Access Compliance Report Public Rights-of-Way (Curb Ramps)

Main Street: **BRENAN_WAY** Cross Street: **MILFORD_RD** Location: **NW**

ADA ID: **RPAT211007135928** Ramp Type: **Type 6 - Directional 1** Initial Pass/Fail: **Fail** Overall Compliance: **No** Severity Score: **15**

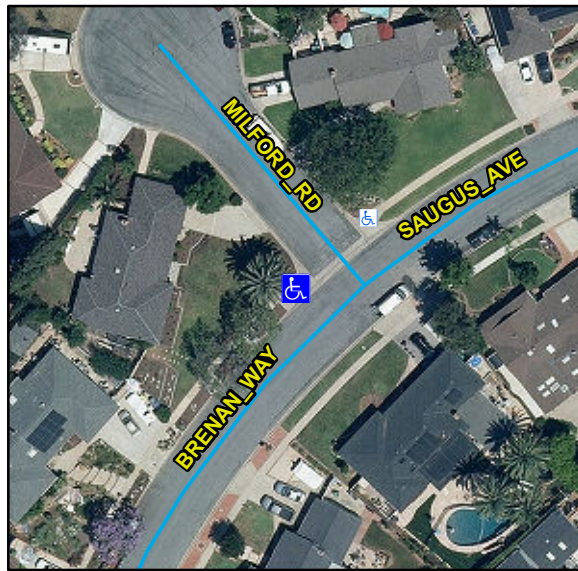
Compliance	Description	Data	Compliance	Description	Data
N/A	Ramp Length (in)	112	N/A	Flare Type LT	
Yes	Ramp Width (in)	60			N/A
Yes	Ramp Run Slope (%)	5.1	N/A	Flare Slope LT (%)	N/A
No	Ramp Cross Slope (%)	6	N/A	Flare Traversable LT	N/A
N/A	Grade Break	N/A	N/A	Flare Type RT	
N/A	Grade Break Slope (%)	N/A			N/A
N/A	Grade Break Cross Slope (%)	N/A	N/A	Flare Slope RT (%)	N/A
	Addl Para Ramp Left?	No	N/A	Flare Traversable RT	N/A
	Addl Para Ramp Right?	No	N/A	DWS Provided	N/A
N/A	Landing Present	N/A	N/A	DWS Contrast	N/A
N/A	Landing Length (in)	N/A	N/A	DWS Length (in)	N/A
N/A	Landing Width (in)	N/A	N/A	DWS Full Width	N/A
N/A	Landing Run Slope (%)	N/A		DWS Offset Type	N/A
N/A	Landing Cross Slope (%)	N/A	N/A	DWS Left Offset (in)	N/A
N/A	Landing Movement Obstructed?	N/A	N/A	DWS Right Offset (in)	N/A
	Landing Movement Type	N/A			
N/A	Landing Shared	N/A			
N/A	Marked Crosswalk 1	No	N/A	Clear Space	Yes
	Crossing 1 Direction	S	N/A	Clear Space To Crosswalk (in)	N/A

Remove & Replace Curb Ramp With Two New Directional Ramps or Equivalent.

R304.5.3, STD 1115
